WIVENHOE DAM

ANNUAL DAM SAFETY INSPECTION 2009

Date of Inspection: 22 October 2009

Inspected by: John Tibaldi – Seqwater

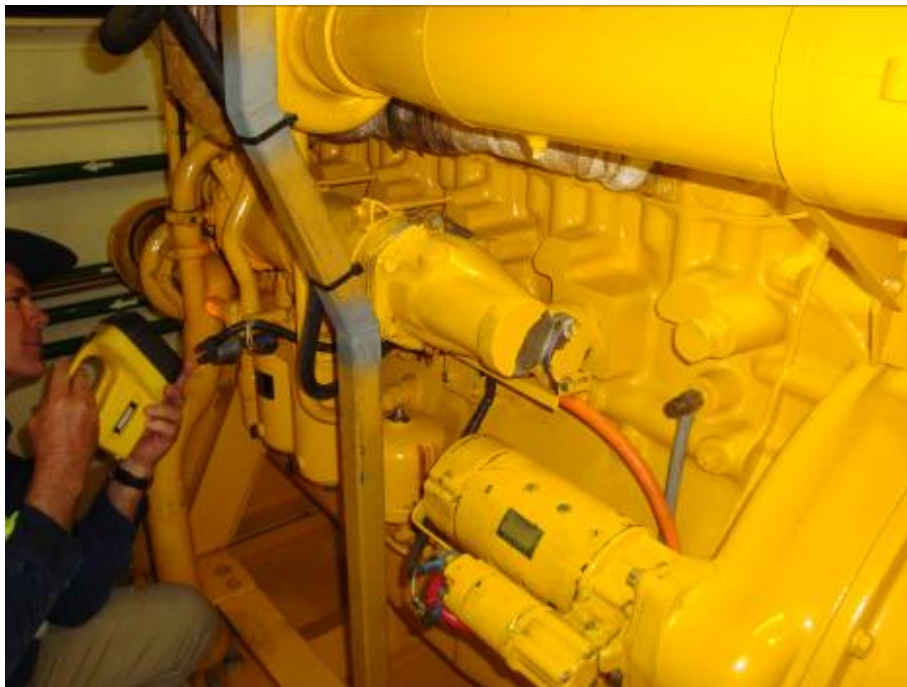
The spillway and associated gates, hoisting gear and cranes looked to be in good condition. The gauge boards that serve as the radial gate position indicators have recently been replaced and are in excellent condition. Undertaking regular routine maintenance in accordance with the dam Operation and Maintenance Manuals appears to be producing good results and it is important that this program is continued. However, it was noted that the electrical condition monitoring program seems to have been discontinued and this is of concern. Trees on the benched areas of the spillway channel, downstream of the radial gates, that were identified as a problem in the 2008 Annual Inspection and have been removed.

The main issues found during the inspection relate to ensuring the on-going reliability of the spillway gates. The mechanical and electrical infrastructure is now over 25 years old and assessments are needed to determine the remaining useful life of this infrastructure and commence planning renewal and refurbishment works.

- ***Undertake a risk assessment of the age and condition of the electrical and hydraulic equipment at the dam to determine remaining useful life of this equipment and develop a plan for renewal and replacement. In particular, the following components require examination***

- ***Radial Gate Electric/Hydraulic System.***
 - ***Radial gate Hydraulic Winch motors.***
 - ***Standby Diesel generator.***
 - ***High Voltage Transformer.***

- ***Radial Gate Fixed Diesel/Hydraulic System.***
 - ***79 Tonne Gantry Crane Electric/Hydraulic System.***
- ***Recommence the electrical condition monitoring program associated with the radial gate infrastructure.***

- ***Install a suitable hydraulic oil overflow collection and oil transfer system to manage hydraulic balancing between the electric hydraulic and fixed diesel hydraulic systems.***

- ***Engage a suitable hydraulic specialist to investigate the recent low hydraulic oil pressure alarms that have occurred during radial gate operations and repair the creeping anchor pin on the 79 tonne Gantry Crane.***

- ***Repair the leak in the Standby Diesel generator oil cooler system. It is considered that this leak requires urgent attention.***
- ***Repair the concrete damage to the spillway floor and replace the missing flap gate on one of the spillway underdrain outlets.***

- ***Initiate a painting program for the downstream sides of the radial gates. It may be sensible to paint one gate per year over the next five years.***
